13B Primrose Hill Gardens

Delegated Report		Analysis sheet		Expiry Date:	te: 16/07/2014		
(Members Briefing)		N/A		Consultation Expiry Date:	26/06/2014		
Officer			Application Number(s)				
Obote Hope			2014/3419/P	2014/3419/P			
Application Address			Drawing Numb	Drawing Numbers			
13B Primrose Gardens London NW3 4UJ			See draft decis	See draft decision notice			
PO 3/4 Area Tea	m Signature	C&UD	Authorised Of	ficer Signature			
	3						
Proposal(s)							
The erection of a full width dormer roof extension with terrace, the installation of a rooflight to the rear flat roof, following the demolition of existing dormer and terrace to the rear elevation.							
Recommendation(s):	Grant Conditional Permission						
Application Type: Full Plann		ing Permission					
Conditions or							
Reasons for Refusal:	Refer to Draf	t Decision Notice					
intormatives.							
Consultations							
Adjoining Occupiers:	No. notified	26	No. of responses	01 No. of a	objections	01

Address: 13B Primrose Gardens London NW3 4UJ

Existing dormer

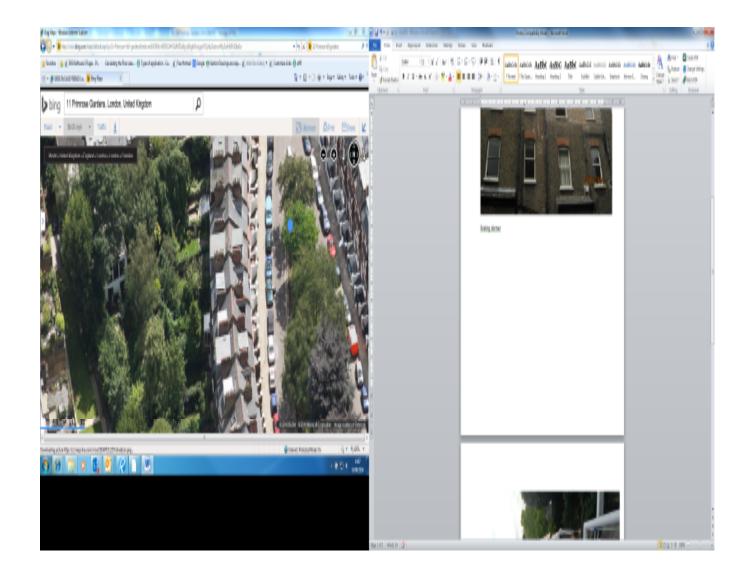
No. electronic	00			
Summary of consultation responses:	Press notice: 05/06/2014 – 29/06/2014 Site notice: 04/06/2014 – 21/06/2014						
CAAC/Local groups comments:	Belsize CAAC – Object to the proposed full width extension as it is too large and dominant and the terrace should be set back by from the edge of the roof by at least a metre. Officer comment: Please see assessment below specifically paragraph 1.7 to 1.9 below.

2.4 The proposed dormer roof extension has been revised in order to maintain some element of uniformity. The proposal relates to the demolition of the existing dormer window which measures approximately 3.2m in width x 2.1m height x 4.2m in depth and the existing terrace measures approximately 5.5m in width x 2.2m in depth.

2.5 The proposed dormer extension would measure approximately 4.0m in depth, between 10m – 9.6m in width due to the existing chimney breast and approximately 2.0m in height. CPG 1 stipulates that dormer roof extensions should be set back by a minimum of 0.5m from the eaves, ridge and side of the roof and that new dormer extension should not be full width CPG 1 further "states that in number, form, scale and pane size, the dormer and window should relate to the façade below and the surface area of the roof. They should appear as separate small projections on the roof surface. They should generally be aligned with windows on the lower floors and be of a size that is clearly subordinate to the windows below".

2.6 However, in light of previous full width dormer extension that was granted consent at 11 and 9 Primrose Gardens the latter was on appeal, it is considered that the proposed dormer extension would not meet the planning guidance as stipulated in CPG 1, partly due to the existing design and in the case of recent consent that were granted for the neighbouring properties. The loss in terms of the size and bulk to the rear elevation of the proposed dormer would not be so significant as to warrant refusal. Furthermore, when viewed in context, it is considered that the proposal would introduce an element of harmony with 9 and 11 Primrose Gardens which does not currently exist.
